UNITED STATES PATENT AND TRADEMARK OFFICE

10/750,069

Office Action Summary	Application No. 10/750,069	Applicant(s) SEVERINSSON, LARS	
	Examiner Saúl J. Rodríguez	Art Unit 3681

DETAILED ACTION

FIG.3.

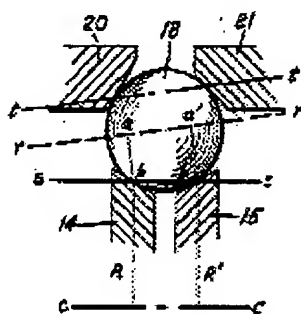
It has been known, however, to use ball instead of geared planets. Carroll, for example, discloses such an arrangement comprising balls (18) flanked by four thrust rings (14, 15, 20, 21), and a circumferential ball holder (19).

Then, it would have been obvious to a person of ordinary skill in the art at the time the invention was made to use balls in the device of WO in view of Carroll for simplicity and cost reduction (Col. 1, lines 14-29).
